Interactive comment on “Emissions factors for gaseous and particulate pollutants from offshore diesel engine vessels in China” by F. Zhang et al.

F. Zhang et al.

Received and published: 14 January 2016

Figure S1 Real-world measurement system for vessels: a) on-board test picture, b) schematic diagram of the portable measurement system

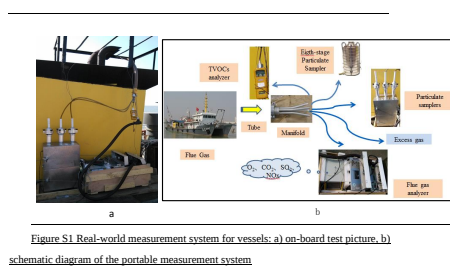
Both reviewers supported the measurement methods and data quality. However, one reviewer mentioned the need to consider the dilution when evaluating organic carbon, and to present more standard emission measures. The other reviewer requested a better treatment of uncertainties.

The real-world measurement system for vessels including on-board test picture and schematic diagram of the portable measurement system has been added in Figure S1. Detailed instruction of the sampling system also has been added in Supporting information, shown as following:

Detailed compositions and procedure of the on-board measurement system were given as follows: The whole measurement system was placed on deck next to the exhaust pipe of the vessel. A slender tube was placed into the vessel exhaust pipe to lead out the flue gas. Then it was divided into five subsamples through a manifold for different analyses and evacuation of the excess gas. The on-board test picture (Figure S1, a)) and schematic diagram of the portable measurement system (Figure S1, b)) are shown in Figure S1.
